Product Change Notification

PCN-PCC-7893-2022

Business Unit	Product Line Code	Type of Change	Action	Date of Issue
PCC - PCB Connectors	AAB	Product Change Notification	Notify Distributors and Field	4/7/2022

<p>MCVR 1,5/-ST-3,5/3,81 (alt-old)</p> 	<p>MCVR 1,5/-ST-3,5/3,81 (neu-new)</p> 
 <p>180° view</p>	 <p>180° view</p>
<p>MCVW 1,5/-ST-3,5/3,81 (alt-old)</p> 	<p>MCVW 1,5/-ST-3,5/3,81 (neu-new)</p> 
 <p>180° view</p>	 <p>180° view</p>

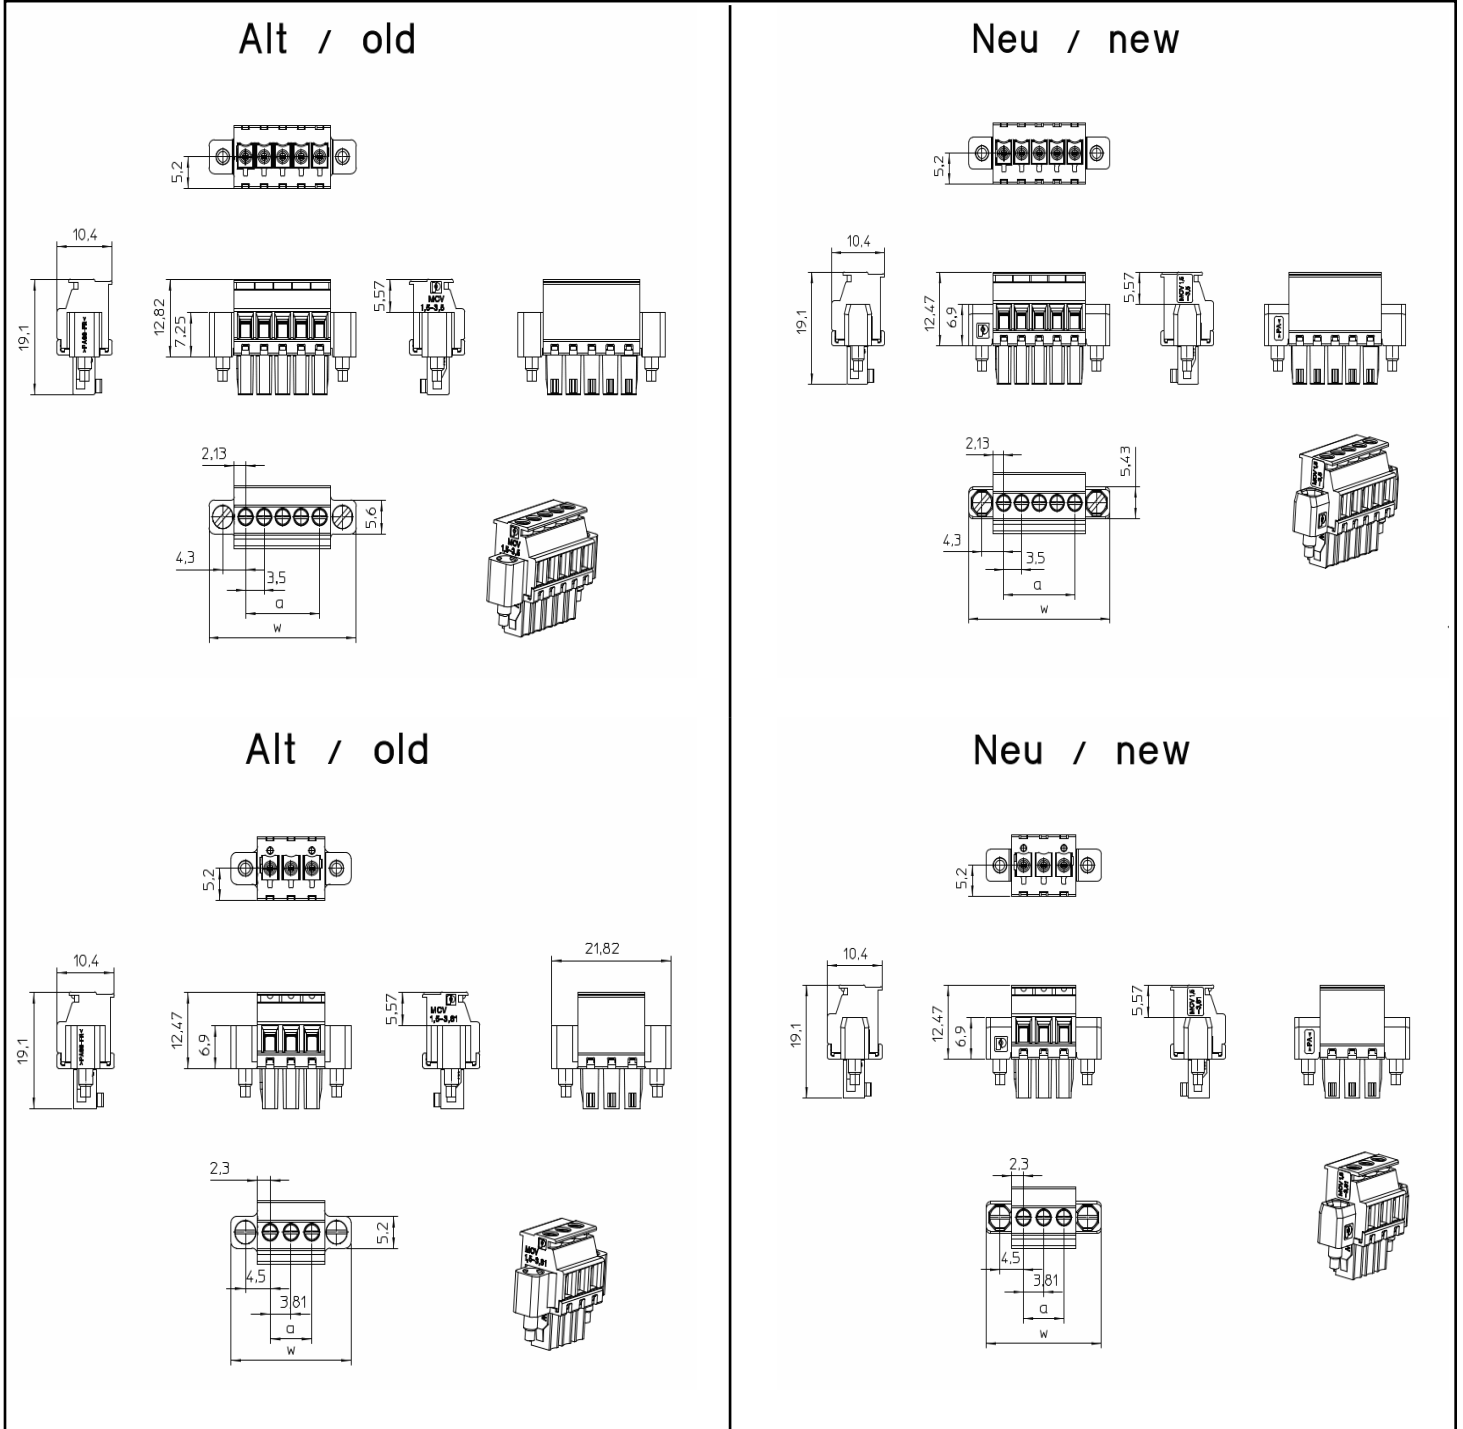
Description for Product Change Notification
As part of ongoing improvement processes, the housings and marking fields for the product families MCVR 1,5/...ST(F) and MCVW 1,5/...ST(F) are being adjusted. The external dimensions of male connectors with 3.5 mm pitch and screw flange will be reduced slightly (see drawings). The external dimensions of male connectors with 3.81 mm pitch remain unchanged. In addition, the marking fields will be updated for all versions (see drawings). The PCB layout, approvals, and technical data remain unchanged.
